Attached, please find a courtesy electronic copy of the RAI response letter with attachments which answers the NRC's Request for Additional Information related to Combined License Application (COLA) Part 2, Tier 2 Sections 2.4S and 2.5S.

July 16, 2008
ABR-AE-08000054

South Texas Project
Units 3 and 4
Docket Nos. 52-012 and 52-013
Response to Requests for Additional Information

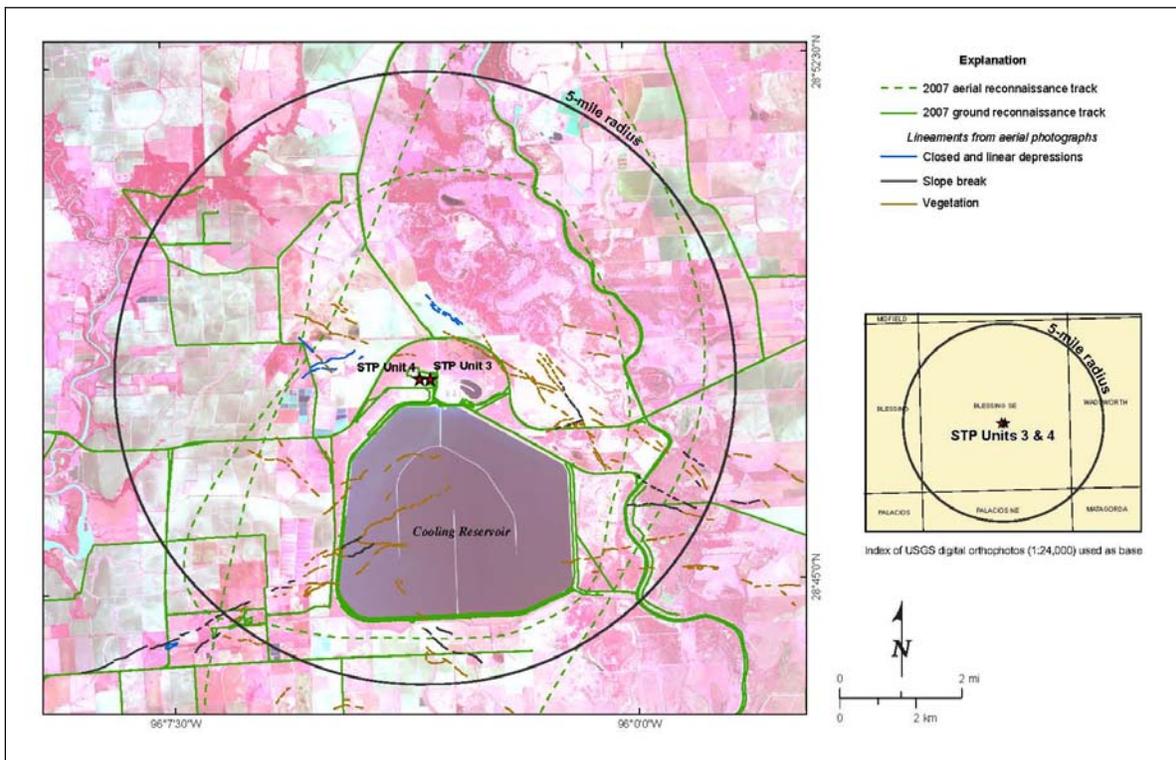
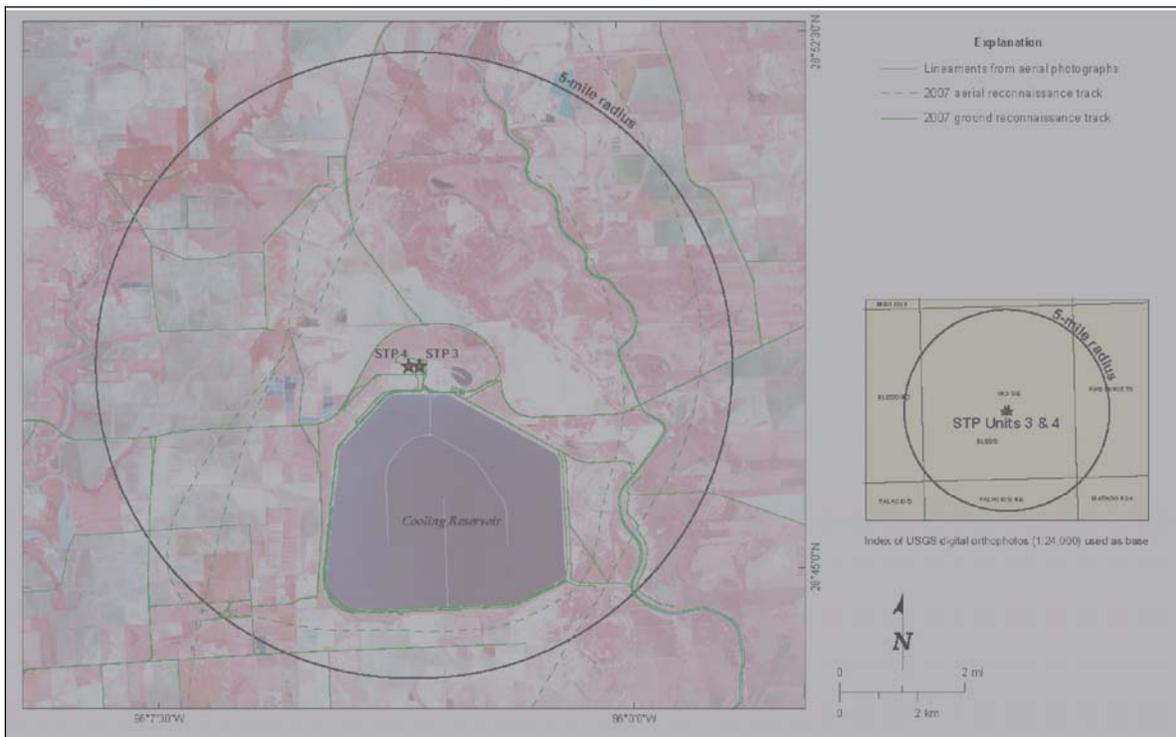
Seismic reflection, well log, and imagery data sources described in Section 2.5S.1.2.4.2.2.1 and Section 2.5S.1.2.4.2.2.1 were not capable of resolving the surface locations of growth faults. Please explain why the investigations for the STP COLA site did not include a LiDAR survey of the site area to reassess evidence for possible subtle surface folding or faulting along growth faults in the site area, particularly along the possible surface trace of fault I.

Figures 2.5S.1-44 and 2.5S.1-45 will be replaced with enhanced figures that show the location of anomalous geomorphic features (e.g., closed and linear depressions, slope breaks, vegetation lineaments) identified in the aerial photo analysis. During the analysis, particular attention was applied to identifying geomorphic features that were spatially correlated with the growth fault projections developed in the COLA and in the UFSAR for STP Units 1 and 2 (STPEGS UFSAR, Rev 13). As stated in Subsection 2.5S.1.2.4.2.2.2, the only strong spatial correlation between distinct lineaments and projected growth faults was with growth fault I/GMO (Figure 2.5S.1-45) suggesting that fault I/GMO is the only fault within the site area with a geomorphic expression of potential Quaternary activity.

As presented in Subsection 2.5S.1.2.4.2.2.2 and apparent in Figure 2.5S.1-45, the monoclinial folding, lineations, and surface projections associated with fault I/GMO are strongly correlated, suggesting that the diversity of methods used to identify growth faults with surface expression (e.g., ground reconnaissance, fault projections, aerial photo analysis) were robust and capable of identifying the surface expression of growth faults if present. The robust nature of these methods then provides confidence that the methods are capable of identifying surface deformation from

Replace Figure 2.5S.1-44 with a revised version that includes lines for lineaments.
